Appendix E – Facility Reports - Buildings

City Hall - Exterior
 401 Grove Street
 Healdsburg, CA

Foss Creek Community Center - First Floor
 1557 Healdsburg Avenue
 Healdsburg, CA

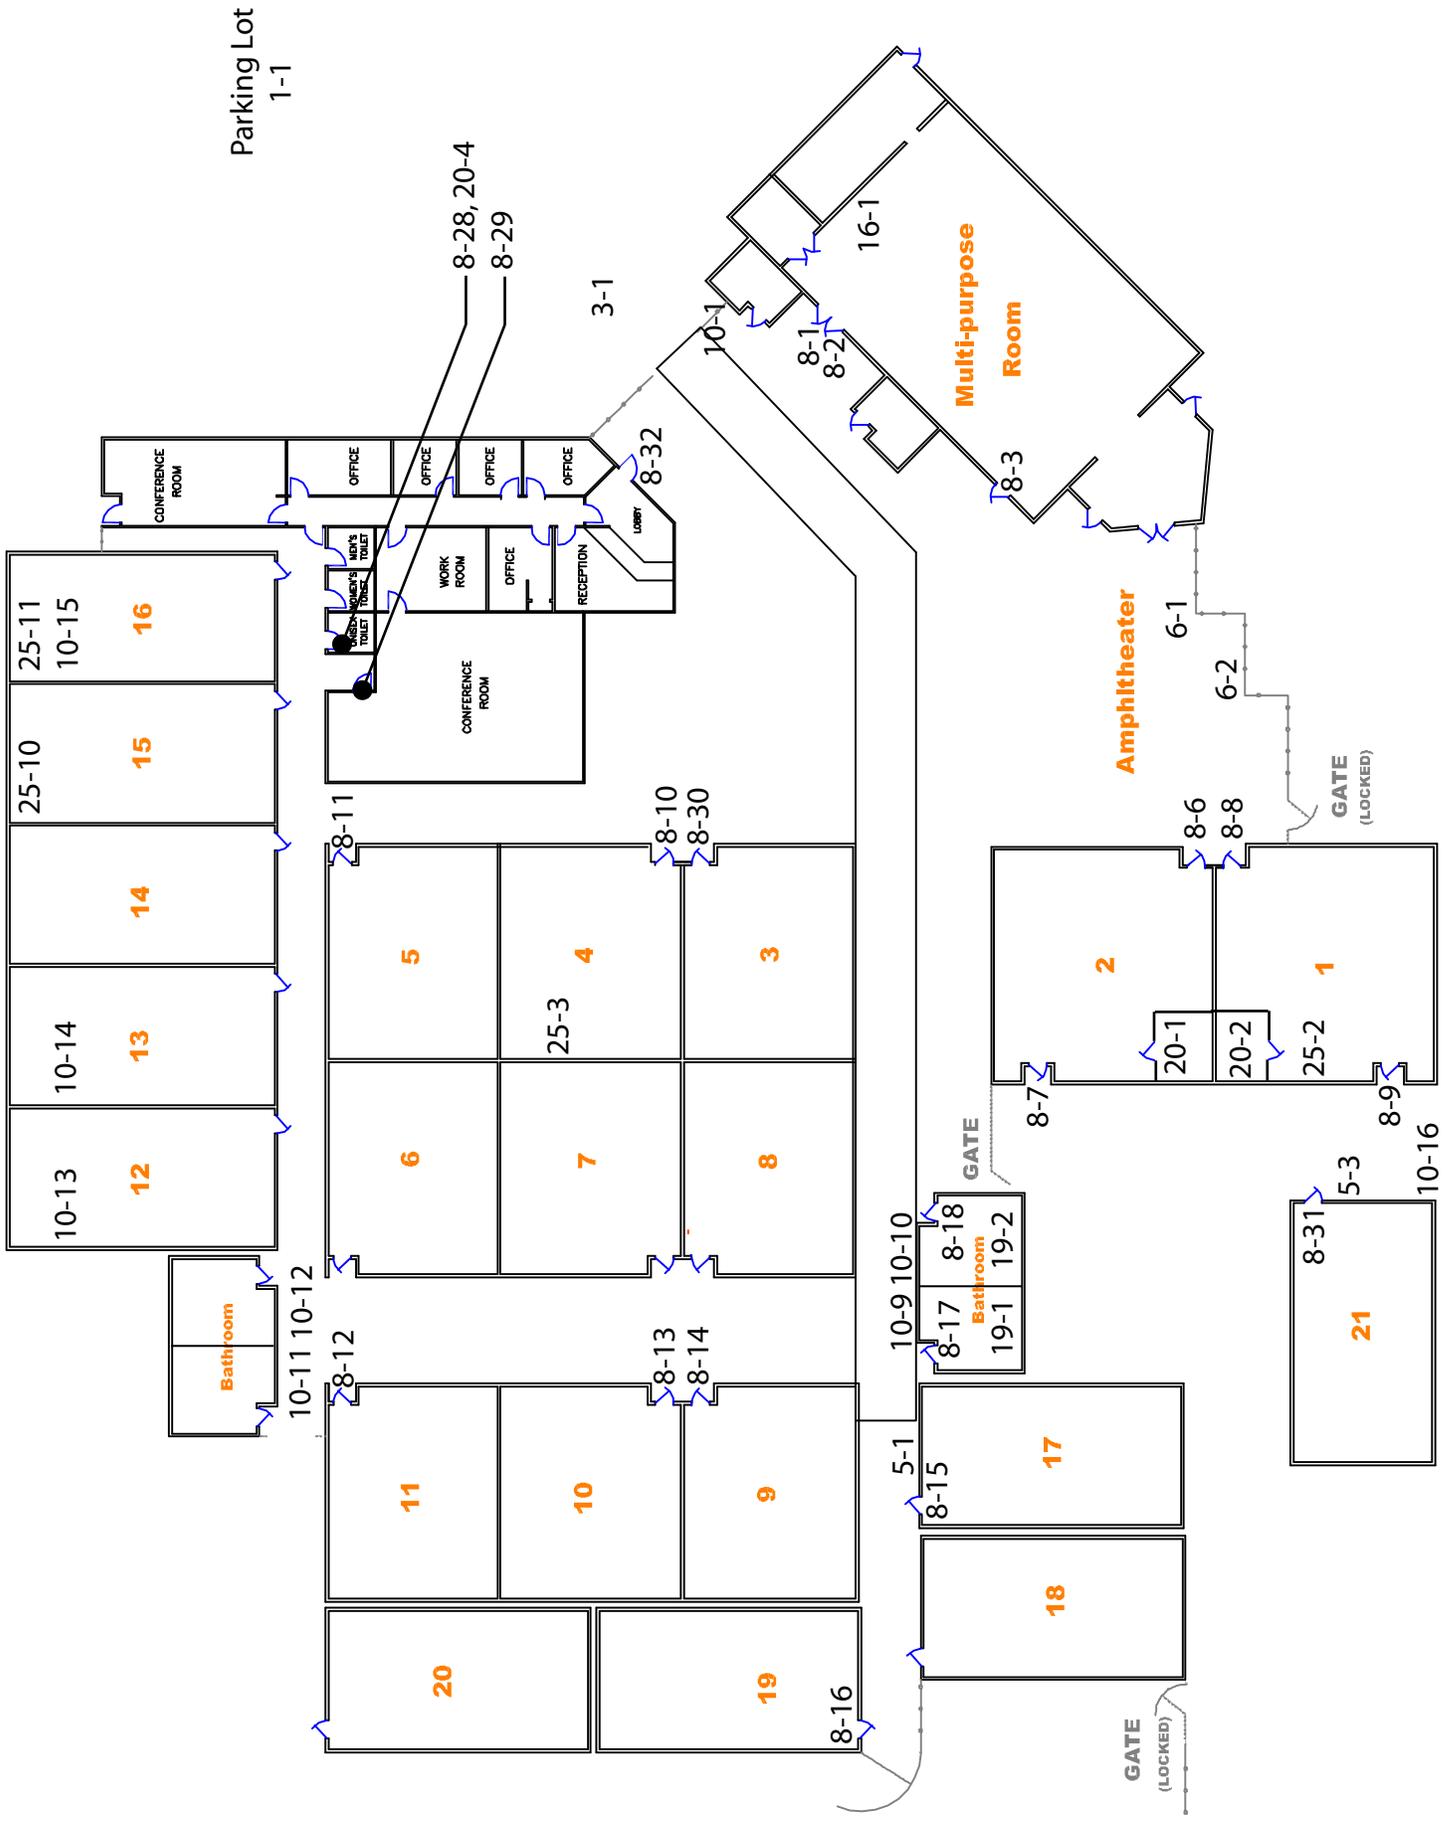
Exterior		
1 - 1	Parking Area	Priority: 1
Provide or modify accessible access aisles		\$300
Notes: The 2 access aisles do not have blue borders.		
State: 1129B.3 #1, 1129B.4 #1		
Federal: 4.6.3		
Install sign		\$400
Notes: Additional language stating "Minimum Fine \$250" not provided at the 4 accessible parking spaces.		
State: 1129B.4		
Federal: -		
Regrade surface		\$7,200
Notes: Slope in van access aisle is 3.2% (2% max). Slopes in the 3 accessible parking spaces exceed 2%. Regrade slopes to not exceed 2% in any direction.		
State: 1129B.3 #4		
Federal: 4.6.3		
3 - 1	Curb Ramp	Priority: 1
Provide detectable warning strip		\$1,000
Notes: Detectable warnings are not provided.		
State: 1127B.5 #7		
Federal: 4.7.7		
Provide surface texturing		\$300
Notes: Surface does not contrast with surrounding sidewalks.		
State: 1127B.5 #5		
Federal: -		
Repair surface		\$250
Notes: There is a 1/2" lip at the curb ramp. Grind down.

State: 1133B.7.4		
Federal: 4.7.2		
5 - 1	Ramp	Priority: 1
Install or modify handrails		\$1,600
Notes: Handrails are mounted 30" (34" to 38") AFF. Top extensions are not provided. Dimensions: 4'W x 11'L.		
State: 1133B.5.5.1		
Federal: 4.8.5 #2, 4.8.5 #5		
Provide level landing		\$2,000
Notes: Slope at bottom landing is 10.7% (2% max).		
State: 1133B.5.4.1, 1133B.5.4.2		
Federal: 4.8.4 #3

Exterior		
5 - 3	Ramp	Priority: 1
Install or modify handrails		\$1,600
Notes: Handrails are mounted 30.5" (34" to 38") AFF. Top extensions are not provided. Dimensions: 4'W x 11'L.		
State: 1133B.5.5.1		
Federal: 4.8.5 #2, 4.8.5 #5		
Provide level landing		\$2,000
Notes: Slope at bottom landing is 9.8% (2% max).		
State: 1133B.5.4.1, 1133B.5.4.2		
Federal: 4.8.4 #3		
6 - 1	Stairway	Priority: 2
Replace stairs		\$1,875
Notes: Risers are 3.5" (4" to 7") high. There are 5 long risers.		
State: 1009.3		
Federal: -		
Install tread striping		\$75
Notes: Indicator stripes are faded. There are 5 risers.		
State: 1127B.4, 1133B.4.4		
Federal: -		
Install or modify handrails		\$3,200
Notes: Handrails are 32" (34" to 38") AFF. Handrail is only provided on one side. There are 5 risers.		
State: 1133B.4.1.1, 1133B.4.2.1		
Federal: 4.9.4, 4.9.4 #5		
6 - 2	Stairway	Priority: 2
Replace stairs		\$1,875
Notes: Risers are 3.5" (4" to 7") high. There are 5 long risers.

Exterior		
10 - 1	Drinking Fountain	Priority:3
Replace or reposition drinking fountain		\$3,500
Notes: "Hi-lo" drinking fountain is not provided. Knee space is 26.5" (27" min).		
State: 1115B.4.6 #1, 1115B.4.6 #2		
Federal: 4.1.6, 4.15.5		
Replace or adjust water controls		\$500
Notes: Operating effort is 10 lbs (5 lbs max).		
State: 1115B.4.6 #4		
Federal: 4.15.4		
10 - 9	Drinking Fountain	Priority:3
Replace or reposition drinking fountain		\$3,500
Notes: "Hi-lo" drinking fountain is not provided. Knee space is 26.5" (27" min).		
State: 1115B.4.6 #1, 1115B.4.6 #2		
Federal: 4.1.6, 4.15.5		
10 - 10	Drinking Fountain	Priority:3
Replace or reposition drinking fountain		\$3,500
Notes: "Hi-lo" drinking fountain is not provided. Knee space is 26.5" (27" min).		
State: 1115B.4.6 #1, 1115B.4.6 #2		
Federal: 4.1.6, 4.15.5		
10 - 11	Drinking Fountain	Priority:3
Replace or reposition drinking fountain		\$3,500
Notes: "Hi-lo" drinking fountain is not provided. Knee space is 26.5" (27" min).

Floor 1		
8 - 1	Door/Gate	Priority: 1
Install or modify permanent room signs		\$250
Notes: Permanent room sign is not centered at 60" AFF nor provide tactile sign.		
State: -		
Federal: 1117B.5.7, 4.30.6		
8 - 2	Door/Gate	Priority: 1
Adjust door closer		\$100
Notes: Operating effort is 6 lbs (5 lbs max).		
State: 1133B.2.5		
Federal: 4.13.11		
8 - 3	Door/Gate	Priority: 1
Adjust door closer		\$100
Notes: Operating effort is 6 lbs (5 lbs max).		
State: 1133B.2.5		
Federal: 4.13.11		
Install or modify permanent room signs		\$250
Notes: Permanent room sign is not centered at 60" AFF nor provide tactile sign.		
State: -		
Federal: 1117B.5.7, 4.30.6		
8 - 6	Door/Gate	Priority: 1
Adjust door closer		\$100
Notes: Operating effort is 15 lbs (5 lbs max).		
State: 1133B.2.5		
Federal: 4.13.11		
Install or modify permanent room signs		\$250
Notes: Permanent room sign is not centered at 60" AFF nor provide tactile sign.		
State: -

Floor 1		
8 - 8	Door/Gate	Priority: 1
Adjust door closer		\$100
Notes: Operating effort is 15 lbs (5 lbs max).		
State: 1133B.2.5		
Federal: 4.13.11		
Install or modify permanent room signs		\$250
Notes: Permanent room sign is not centered at 60" AFF nor provide tactile sign.		
State: -		
Federal: 1117B.5.7, 4.30.6		
8 - 9	Door/Gate	Priority: 1
Adjust door closer		\$100
Notes: Operating effort is 17 lbs (5 lbs max).		
State: 1133B.2.5		
Federal: 4.13.11		
8 - 10	Door/Gate	Priority: 1
Provide or modify door kickplate		\$100
Notes: Doorstop is mounted on kickplate.		
State: 1133B.2.6		
Federal: -		
8 - 11	Door/Gate	Priority: 1
Install or modify permanent room signs		\$250
Notes: Permanent room sign is not centered at 60" AFF nor provide tactile sign.		
State: -		
Federal: 1117B.5.7, 4.30.6		
Provide or modify door kickplate		\$100
Notes: Doorstop is mounted on kickplate.		
State: 1133B.2.6		
Federal: -		
Provide additional strike edge clearance		\$100

Floor 1		
19 - 1	Multiple User Restroom	Priority:2
Install sign		\$250
Notes: Federal required sign is not provided on the latch side of the door.		
State: 1115B.6, 1117B.5.1 #1		
Federal: 4.30.4		
Replace or reposition dispensers or mirrors		\$400
Notes: Towel dispenser is mounted 49" (40" max) and soap dispenser is mounted 47" (40" max) AFF.		
State: 1115B.8.3		
Federal: 4.23.7		
Replace or reposition dispensers or mirrors		\$200
Notes: Mirror is mounted so bottom of reflecting surface is 43" (40" max) AFF.		
State: 1115B.8.1		
Federal: 4.19.6		
Replace or reposition urinal		\$3,500
Notes: Urinal flush control is mounted 48" (44" max) AFF.		
State: 1115B.4.2 #2		
Federal: 4.18.2		
Modify lavatory/counter clearances		\$3,500
Notes: Height of lavatory sink is 34-3/8" (34" max) AFF.		
State: 1115B.4.3 #2		
Federal: 4.19.2		
Provide or replace stall door hardware		\$100
Notes: U-shape handle not provided on the back of the compartment door. Compartment door is not self-closing.

Community Development Center
 427 and 435 Allan Court
 Healdsburg, CA

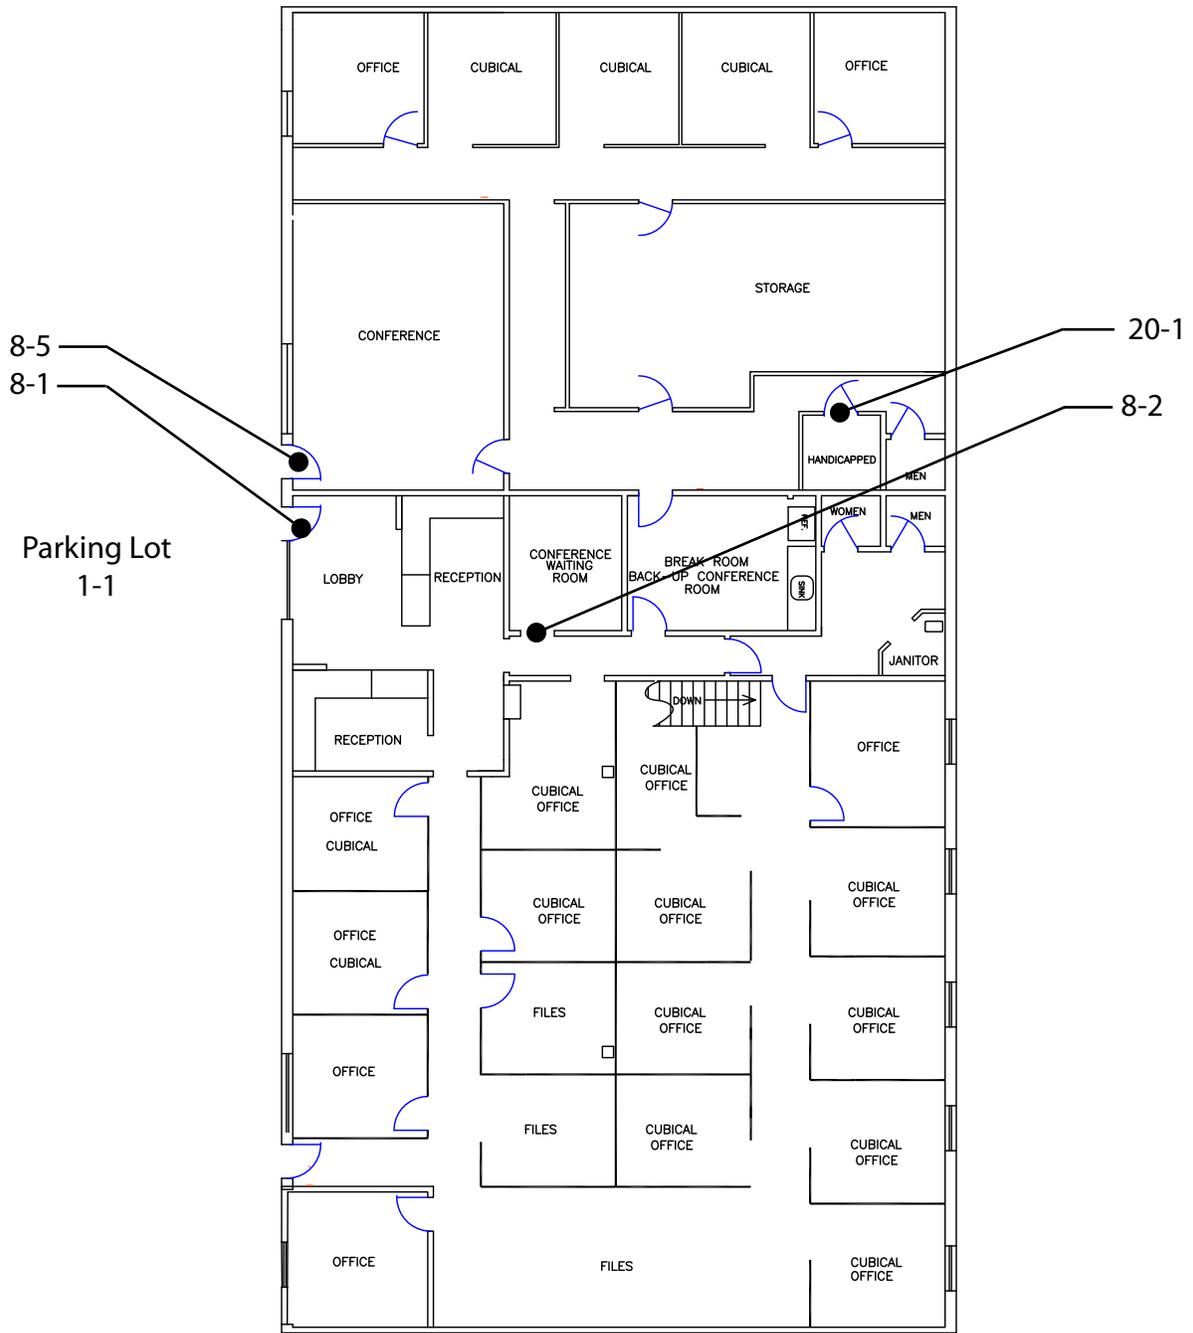
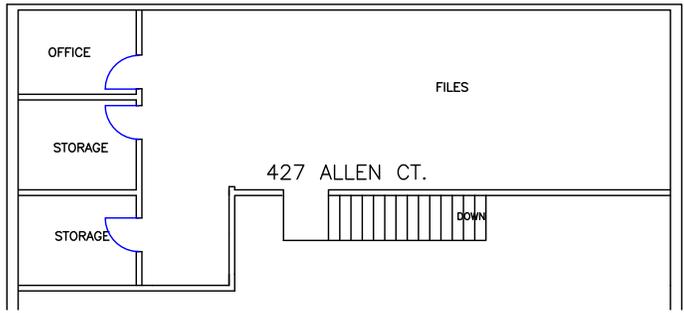
Exterior		
1 - 1	Parking Area	Priority: 1
Install sign for unauthorized parking		\$400
Notes: Tow-away sign is not provided.		
State: 1129B.4, 1133B.8.6.3		
Federal: -		
Regrade surface		\$3,600
Notes: Slope in the accessible parking space is 2.9% (2% max). Slope in the access aisle is 2.6% (2% max) Regrade slopes to not exceed 2% in any direction. Surface material is asphalt.		
State: 1129B.3 #4		
Federal: 4.6.3		
Provide or modify accessible spaces		\$250
Notes: Stall is 15'7" (18' min) long. Extend parking space.		
State: 1129B.4 #1		
Federal: 4.6.3		
Provide or modify accessible access aisles		\$150
Notes: Access aisle does not have blue borders.		
State: 1129B.3 #1, 1129B.4 #1		
Federal: 4.6.3		
Install sign		\$100
Notes: Additional sign stating "Minimum Fine \$250" not provided.		
State: 1129B.4		
Federal: -

Floor 1		
8 - 1	Door/Gate	Priority: 1
Provide sign(s) indicating accessible entries and facilities		\$250
Notes: Accessible entry is not marked with the International Symbol of Accessibility.		
State: 1117B.5.8.1.2, 1127B.3		
Federal: 4.13.6		
Adjust door closer		\$100
Notes: Operating effort is 9 lbs (5 lbs max).		
State: 1133B.2.5		
Federal: 4.13.11		
Provide or modify door kickplate		\$100
Notes: Kickplate is 3.75" (10" min) high.		
State: 1133B.2.6		
Federal: -		
Increase or provide maneuvering or clear floor area		\$2,500
Notes: Slope on the swing-side of the door is 3.3% (2% max). Regrade slope to not exceed 2% in any direction.		
State: 1133B.2, 1133B.2.4.2, 1133B.7.5		
Federal: 4.13.6		
Install or modify permanent room signs		\$250
Notes: There is an illuminated exit sign but tactile sign is not provided.		
State: 1011.3 #3		
Federal: -		
8 - 2	Door/Gate	Priority: 2
Replace or adjust door hardware		\$300

Floor 1		
8 - 3	Door/Gate	Priority: 2
Increase or provide maneuvering or clear floor area		\$2,500
Notes: Level space on the swing-side of the door is 46" (48" min).		
State: 1133B.2, 1133B.2.4.2, 1133B.7.5		
Federal: 4.13.6		
Provide additional strike edge clearance		\$3,000
Notes: Strike-edge clearance on the push-side of the door is 8" (12" min).		
State: 1133B.2.4.3		
Federal: 4.13.6		
8 - 5	Door/Gate	Priority: 1
Provide sign(s) indicating accessible entries and facilities		\$250
Notes: Accessible entry is not marked with the International Symbol of Accessibility.		
State: 1117B.5.8.1.2, 1127B.3		
Federal: 4.13.6		
Adjust door closer		\$100
Notes: Operating effort is 12 lbs (5 lbs max).		
State: 1133B.2.5		
Federal: 4.13.11		
Provide or modify door kickplate		\$100
Notes: Kickplate is 3.75" (10" min) high.		
State: 1133B.2.6		
Federal: -		
Increase or provide maneuvering or clear floor area		\$2,500
Notes: Slope on the swing-side of the door is 6.2% (2% max). Regrade slope to not exceed 2% in any direction.

Floor 1		
8 - 6	Door/Gate	Priority:2
Replace or adjust door hardware		\$300
Notes: Door hardware is a doorknob and requires grasping and twisting.		
State: 1133B.2.5.2		
Federal: 4.13.9		
Install or modify permanent room signs		\$250
Notes: Permanent room sign is centered 65.5" (60" absolute) AFF. Tactile sign is not provided.		
State: -		
Federal: 1117B.5.7, 4.30.6

Floor 1		
20 - 1	Single User Restroom	Priority:2
Install sign		\$250
Notes: Federal required sign is not provided on the latch side of the door.		
State: 1115B.6, 1117B.5.1 #1		
Federal: 4.30.4		
Replace or reposition dispensers or mirrors		\$200
Notes: Mirror is mounted so bottom of reflecting surface is 44.25" (40" max) AFF. Lower mirror.		
State: 1115B.8.1		
Federal: 4.19.6		
Replace or reposition dispensers or mirrors		\$200
Notes: Towel dispenser is mounted 45" (40" max) AFF. Lower towel dispenser.		
State: 1115B.8.3		
Federal: 4.23.7		
Modify lavatory/counter clearances		\$3,500
Notes: Clear space beneath the lavatory sink is 28-5/8" (29" min) high. The space under the bowl is 25.5" (27" min) when measured 8" from the front edge.		
State: 1115B.4.3 #2		
Federal: 4.19.2		
Replace or reposition fixtures		\$1,000
Notes: Clear space from the wall to the centerline of the water closet is 16.25" (18" absolute).
